**Addendum No. 1**

To: Interested Parties  
From: John E. Van Riper, Project Engineer  
Division of Engineering  
Date: Thursday, September 26, 2019  
Project: 2219 Chestnut Grove Road Culvert Replacement

2219 Chestnut Grove Road Culvert Replacement

**8'-0"x3'-0"x14'-0" TYPE 1 BOX CULVERT  
WASHINGTON CO. DIV. OF ENG'G.  
2219 CHESNUT GROVE ROAD  
SHARPSBURG, MD**

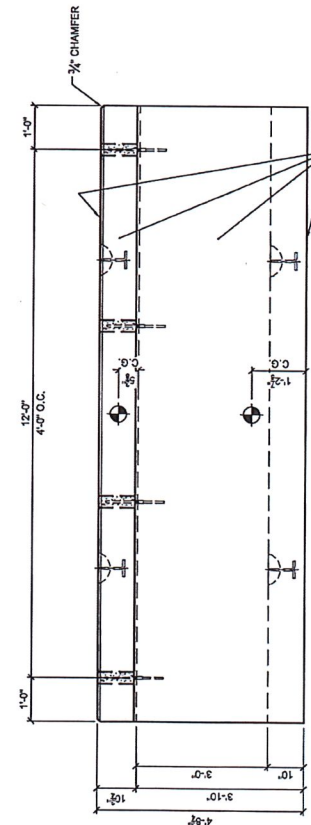
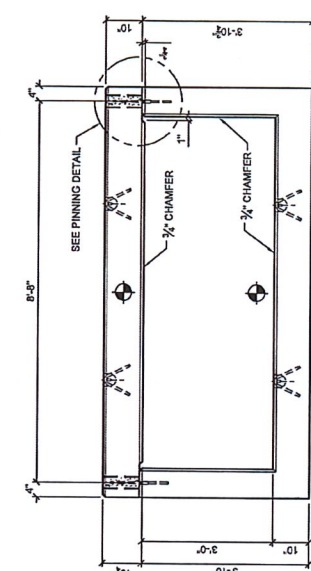
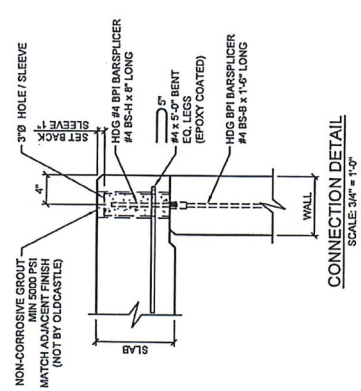
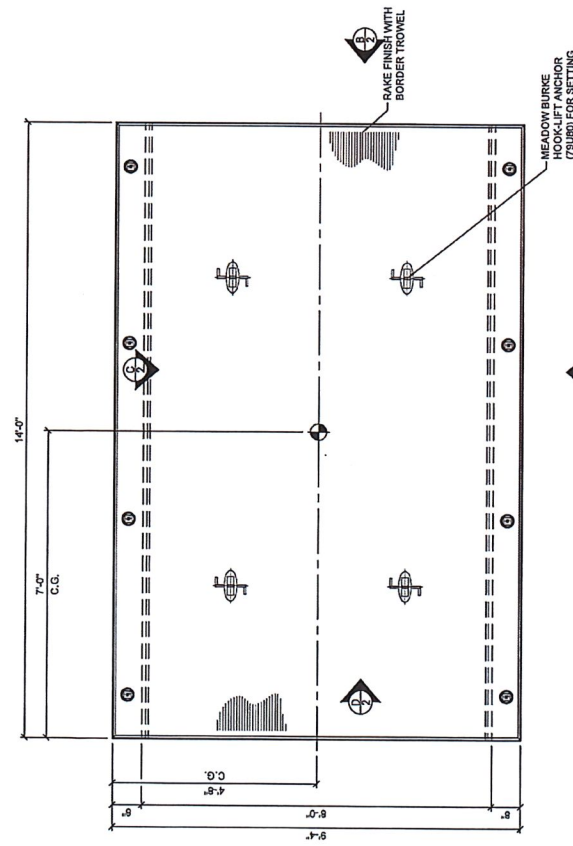
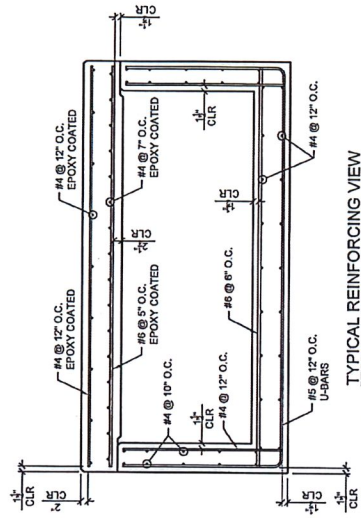
- Item 1.01      **Question 1: I assume the culvert is just one section. Do you know the weight?** The culvert is two sections. Section 1 is the Top Slab at 17,340 lbs. and the second section is the Base Section at 24,908 lbs. The shop drawings have been attached.
